SUZUKI MOTOR CORPORATION

Page	1 / 5
Date	Feb. 11, 2011
Our ref.	UN-110211

RE : Rectifier Recall Campaign

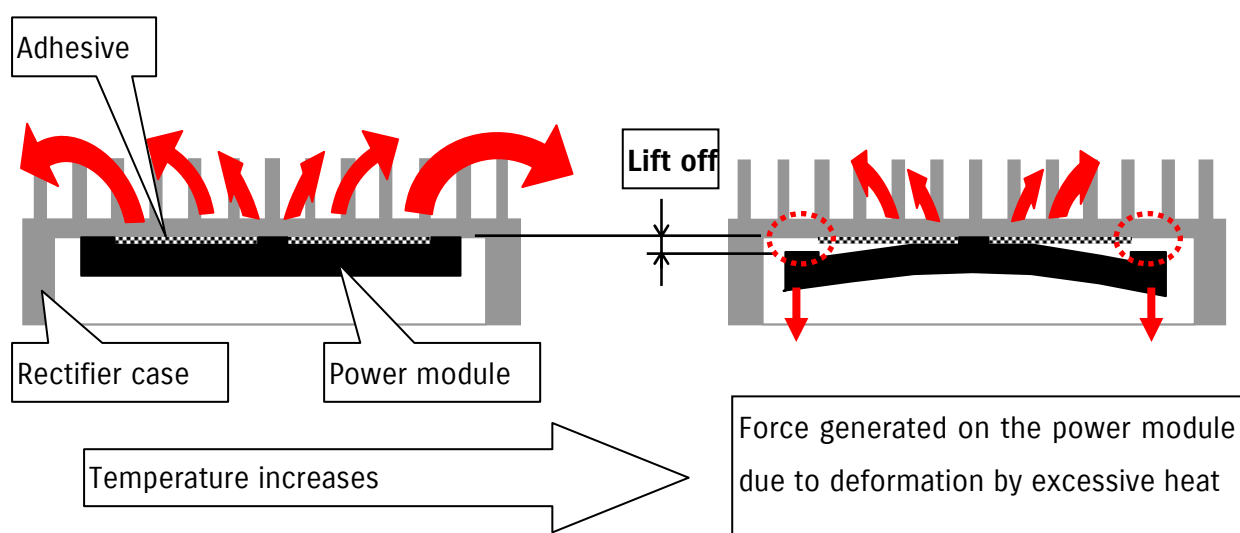
2 pcs of Bolt to install rectifier are included to 32800-47810-RX0 (made by Shindengen) only as height of the rectifier mounting is lower than the original one.
